Fargo VAMC – Refurbish Elevators and Replace Controls

Fargo, North Dakota
Project #19-2481

MARCH 26, 2024

ADDENDUM NO. 2

3 FLOOR PLAN - ELEVATOR 12 - TYPICAL
1/4" = 1'-0"

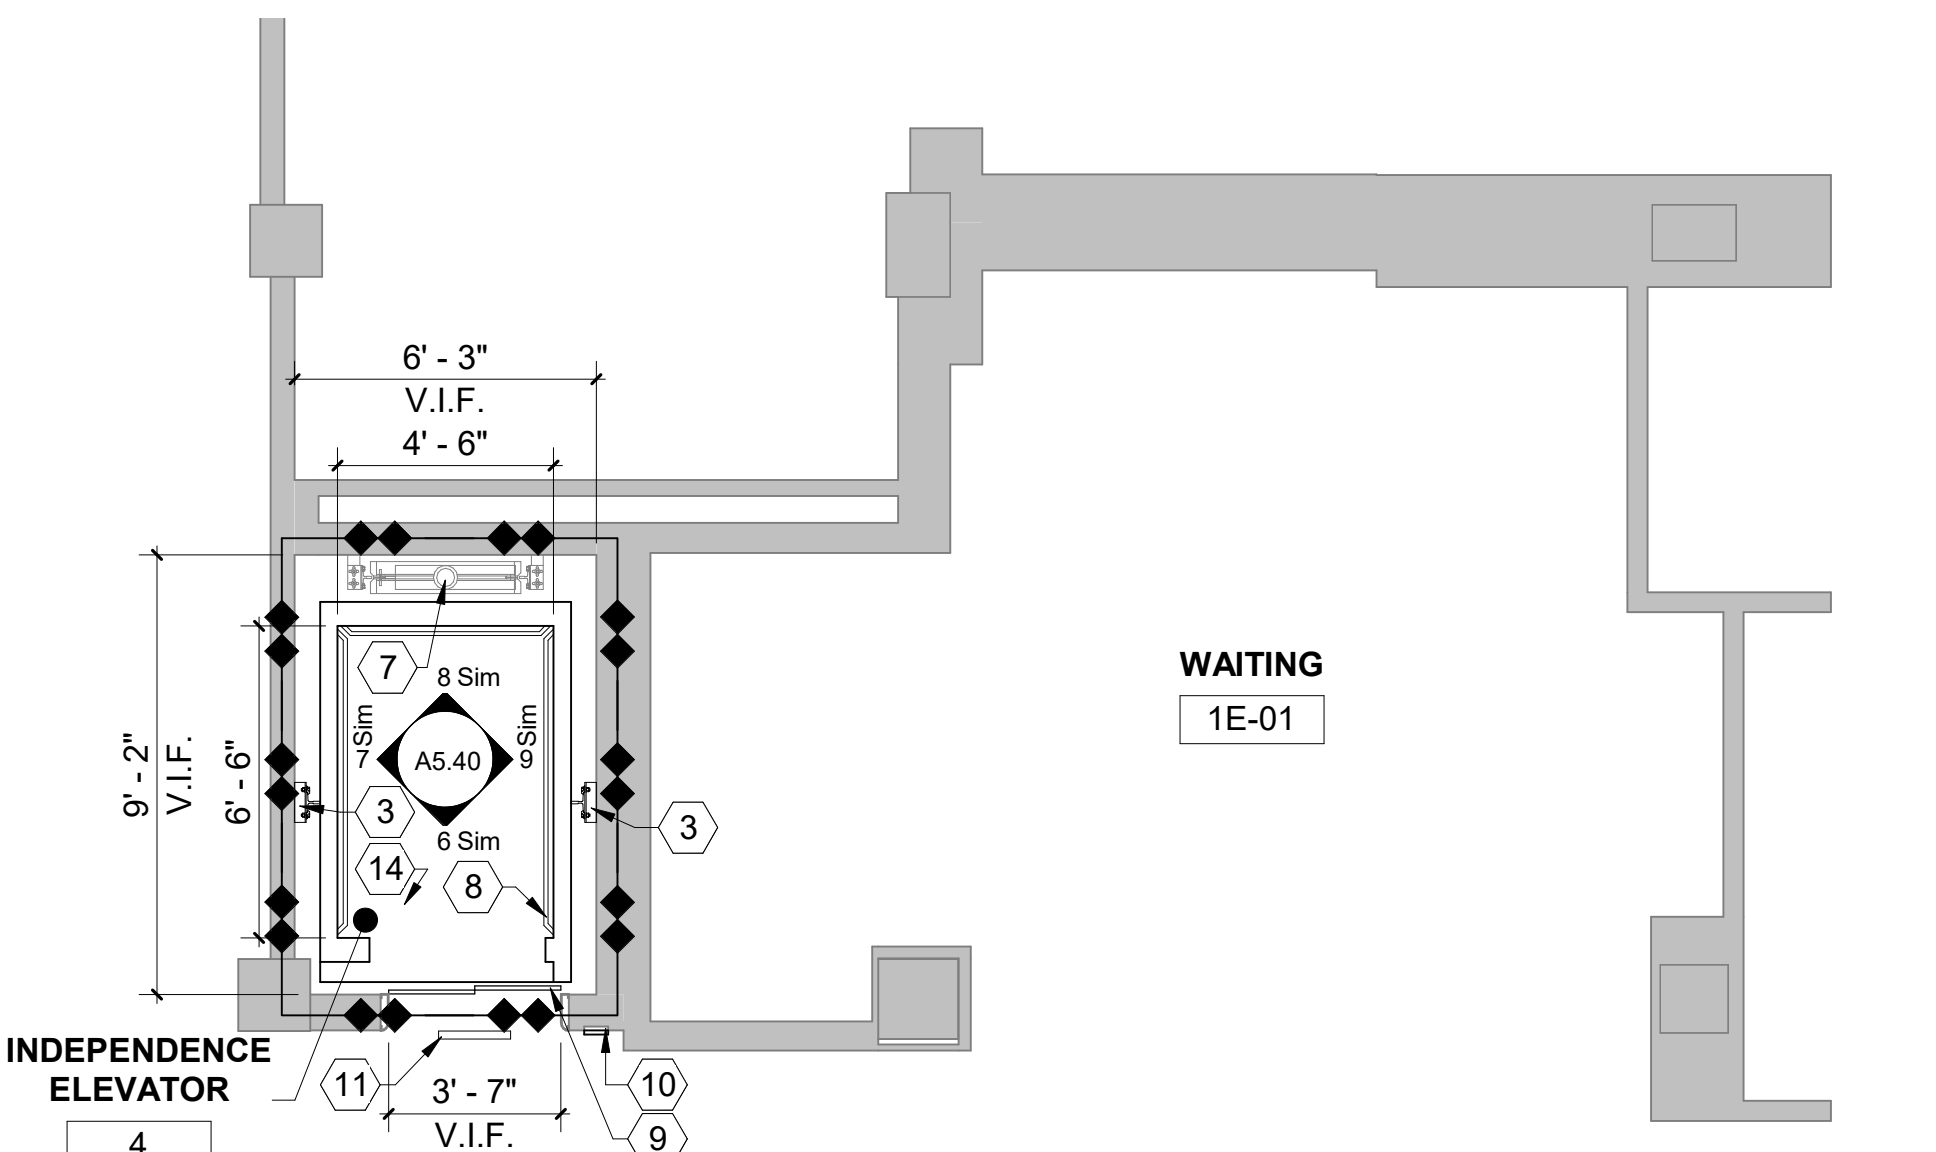
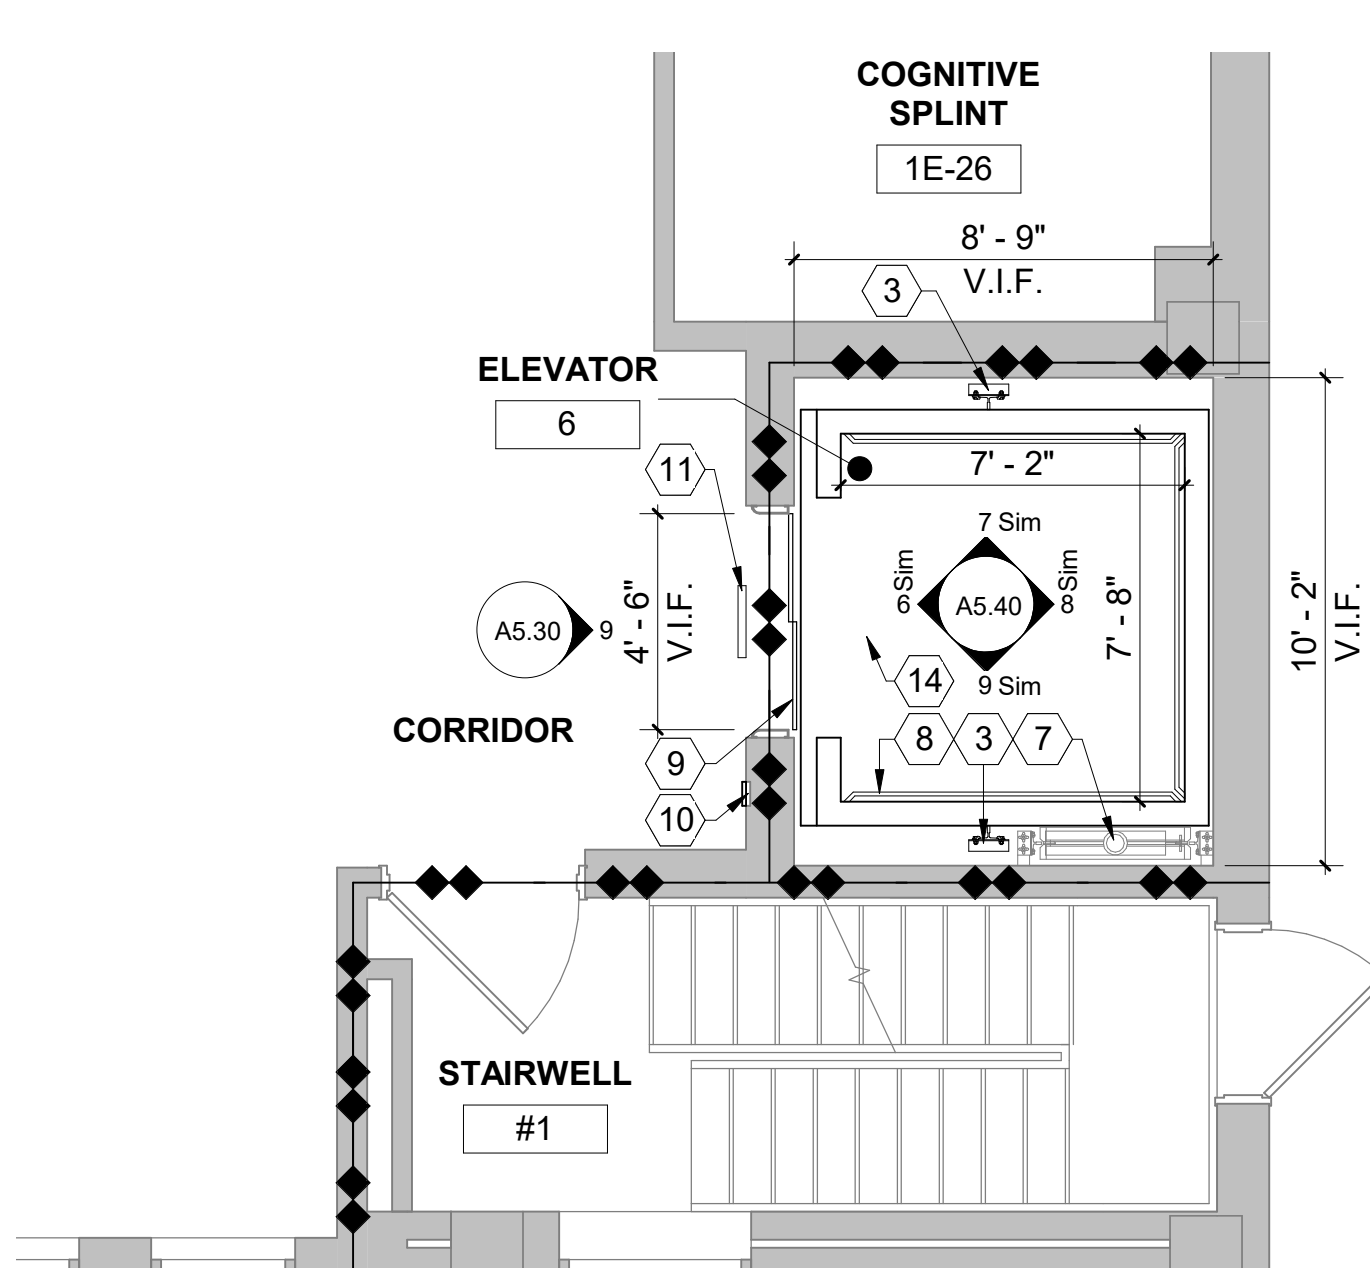
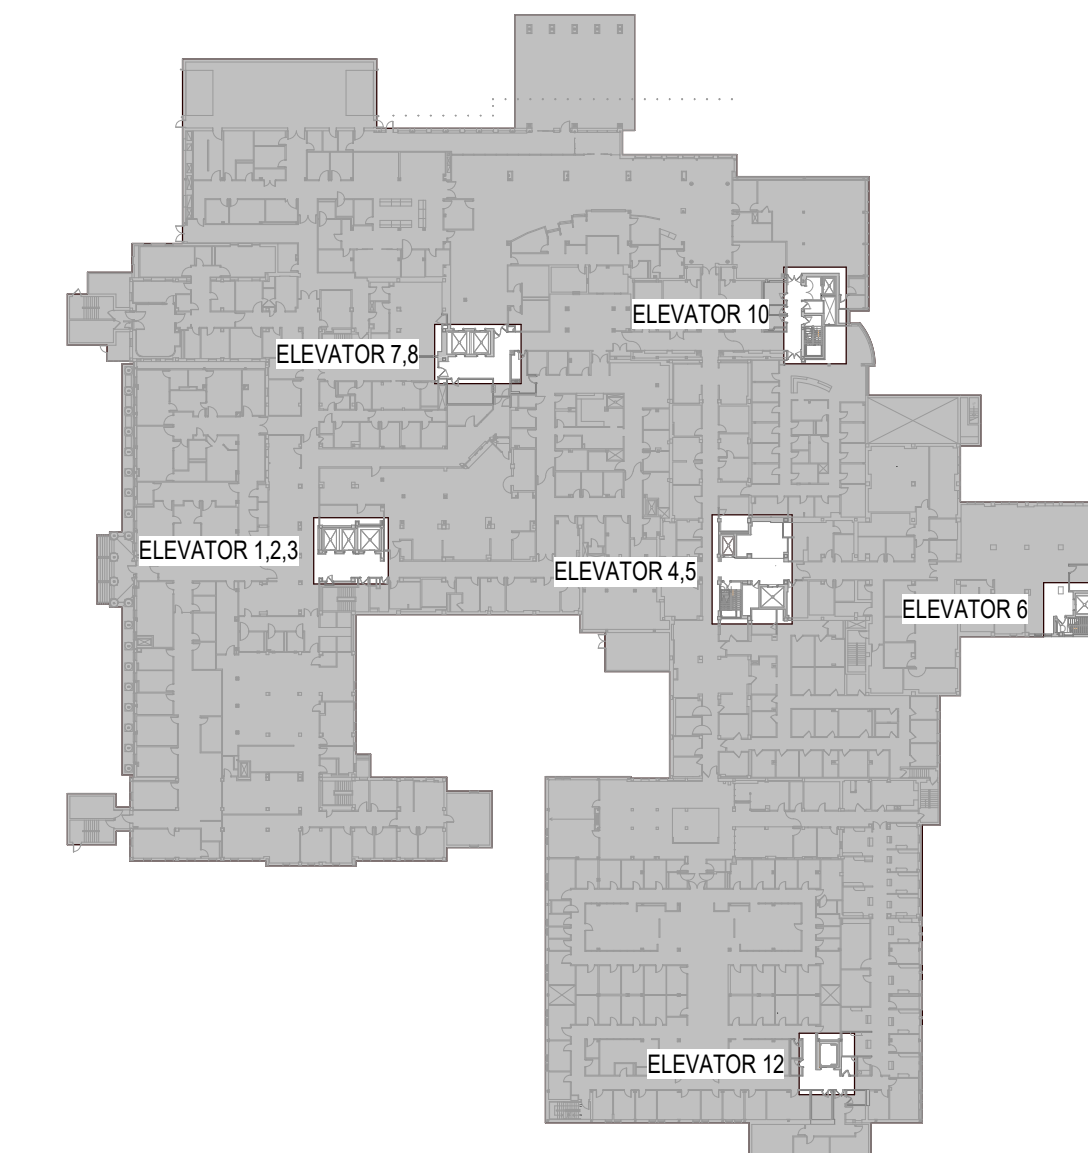
Drawing Sheet A5.21 ENLARGED PLANS – See revised drawing sheet for the adjustment of keynotes # 3, 9, 15.

- NOT USED.
- RESILIENT TILE FLOORING. SEE SPECIFICATIONS.
- REPLACE EXISTING LOWER SECTION OF GUIDE RAILS (APPROX 20 LF AT EACH RAIL) DUE TO WATER DAMAGE. APPLIES TO ELEVATOR 7 & 8 ONLY.
